CITY OF ALBUQUERQUE

RE: **Route 66 Plaza**
Grading and Drainage Plan
Engineers Stamp Date 6/16/16 (K19D043)

ROUTE 66 PLAZA - LIVE/WORK DEVELOPMENT

SITE PLAN & PROJECT INFORMATION

1 GRADING & DRAINAGE PLAN

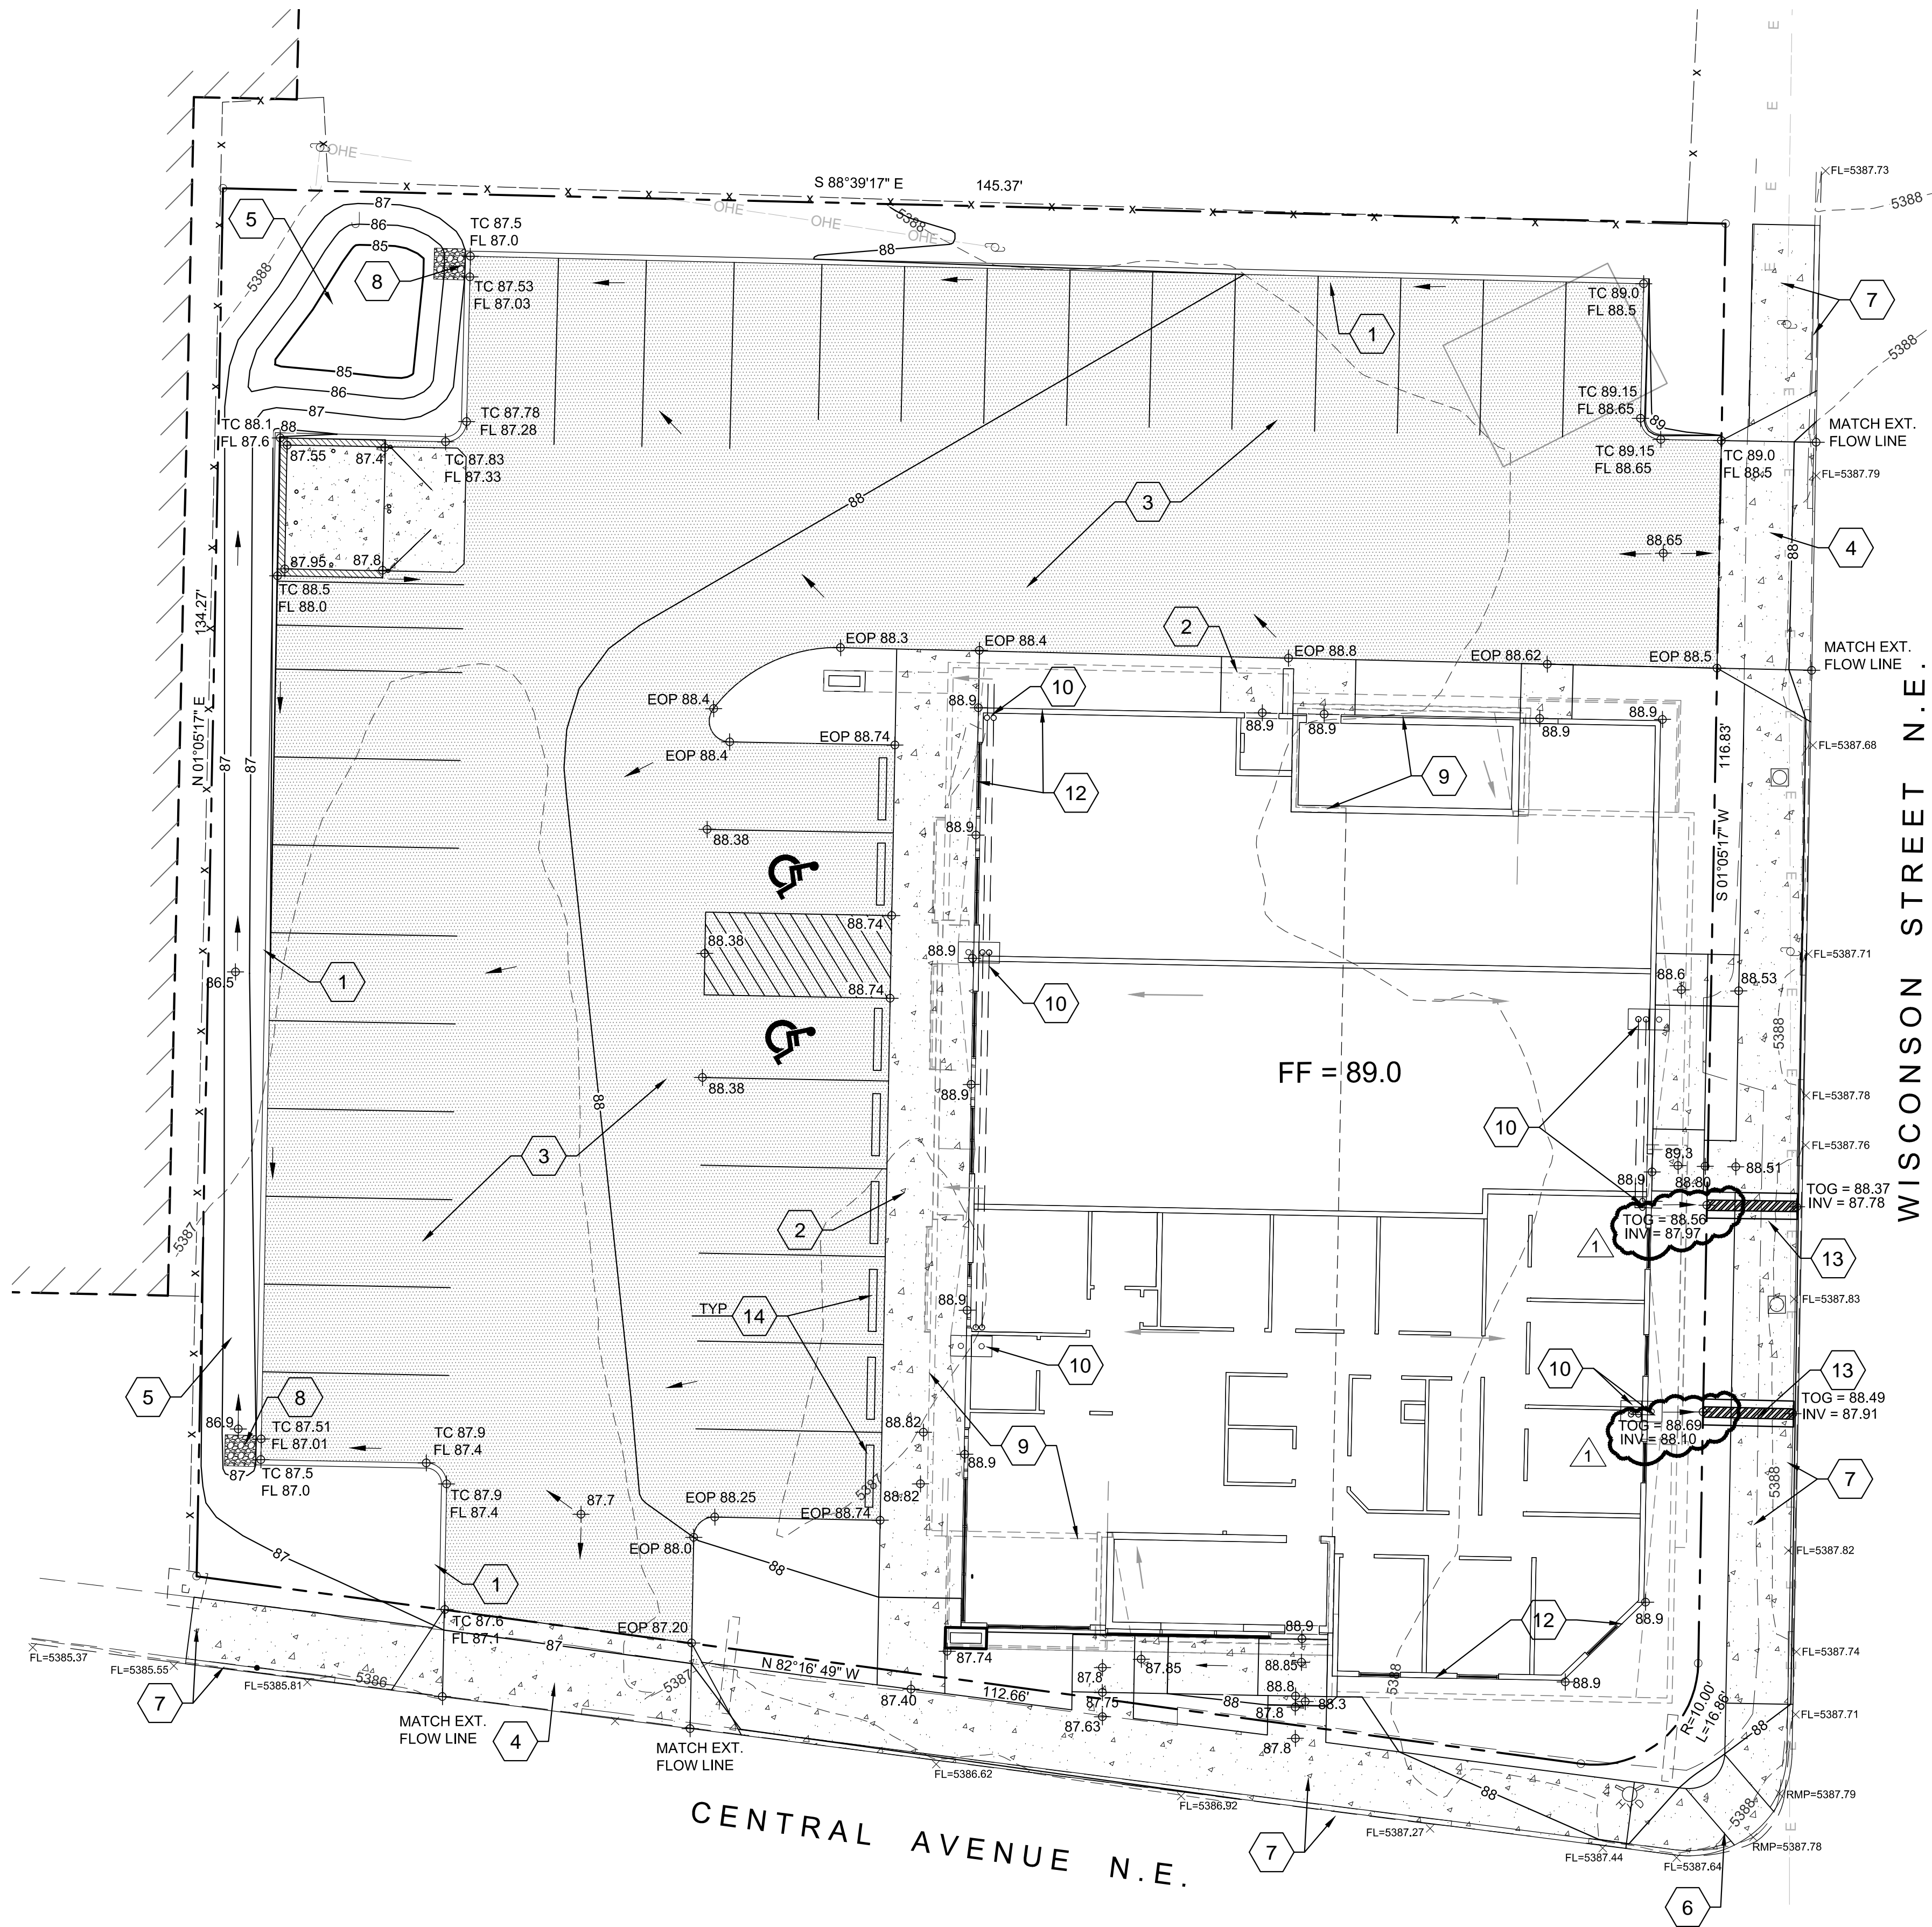
Based upon the information provided in your submittal received 1/5/17, with red line corrections added 1/9/16 this plan is approved for Grading Permit and Building Permit.

Please attach a copy of this approved plan with red line corrections dated 1/5/17 to the construction sets in the permitting process prior to sign-off by Hydrology. If this plan is not in the building permit set with the corrections there will be a delay in the permitting process.

Contact Jason Rodriguez at 235-8016 to schedule an inspection for the side walk culvert before the concrete is poured. A separate Excavation/Barricading Permit is required for SO-19 construction within City ROW. Please inform the owner/contractor that a copy of this approval letter must be on hand when applying for the permit.
